Designer's Response

Project	Bonhams Field, Yapton
Project Number	23018

Comments Received From Arun District Council

Date of Response 29 March 2021 (Resubmission of Discharge of Conditions Application).

Image 1 - Catchment F – Causeway Flow Results for 1:10 plus 40% Allowance for Climate Change

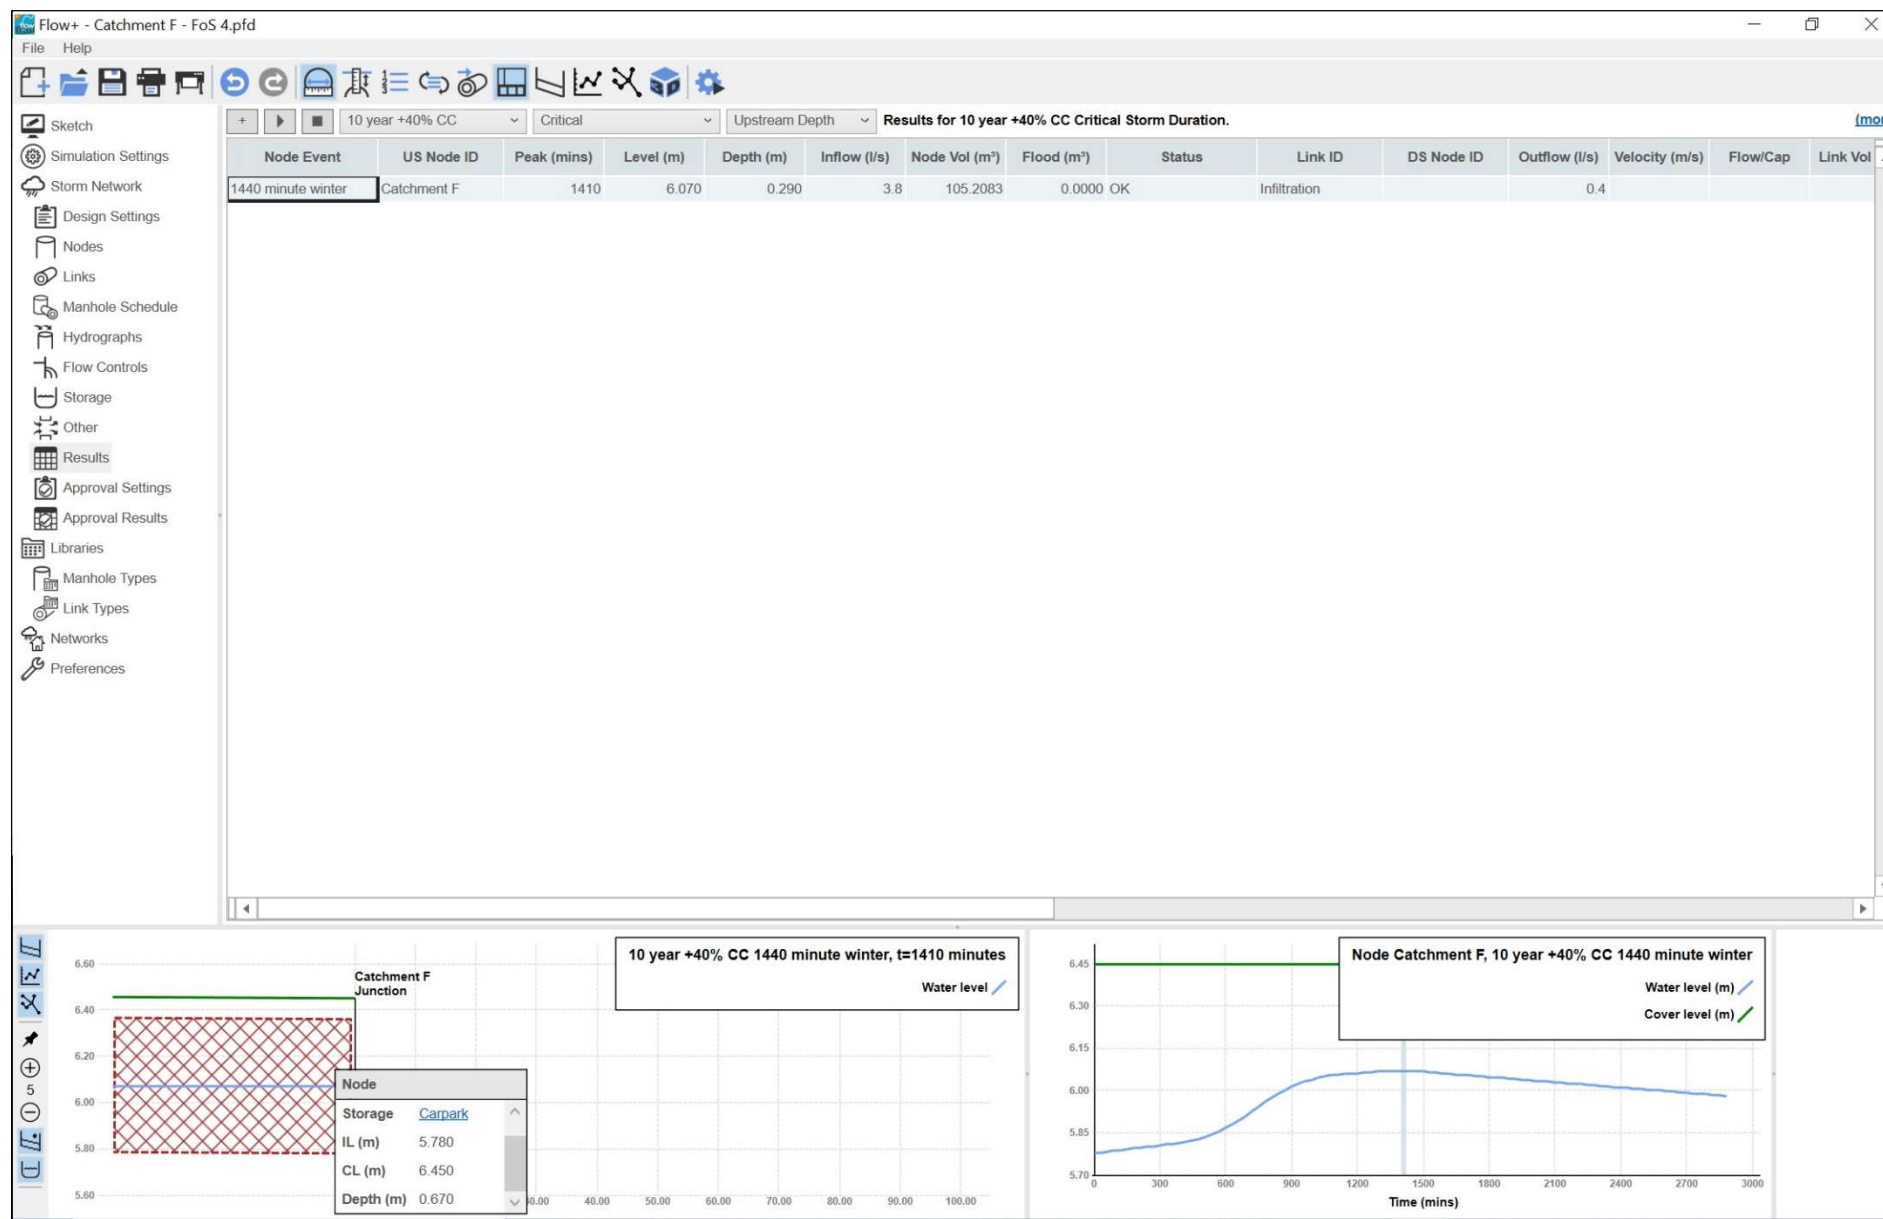
Comment / Query		Designer's response
	<u>Arun District Council comment 16 March 2021</u>	
4	You have not provided calculations showing the half drain time for the 10 year plus cc event for catchments F and H. The only half drain times provided in calculations are for the critical 100 year plus 40%cc event. The table in your report states that the half drain time for the 10 year plus cc event for catchment H is 960mins. This appears to be the node event, rather than the half drain time.	The half drain times have been based upon the peak storage requirement for the 1:10 year storm event with a 40% allowance for climate change as the infiltration blankets storage systems for both Catchments F and H only reach half capacity during the critical storm for this event, therefore the node event has been referenced. Catchment F and H have been designed to provide twice the storage required for the critical 1:10 year storm event with a 40% allowance for climate change. When the critical storage requirements for this storm event occurs the system only reaches half full (or half drained) meaning a replica storm within a 24-hour period could still be accommodated, therefore the request has been met. Without lowering the cover level of the storage node Causeway Flow does not accurately record the half drain time for the 1:10 plus 40% climate change allowance storm event. We have therefore provided screenshots showing the Causeway Flow outputs for the critical 1:10 plus 40% climate change allowance storm which demonstrates the system only reaches 50% capacity for this storm event, which are located at the rear of this design response.
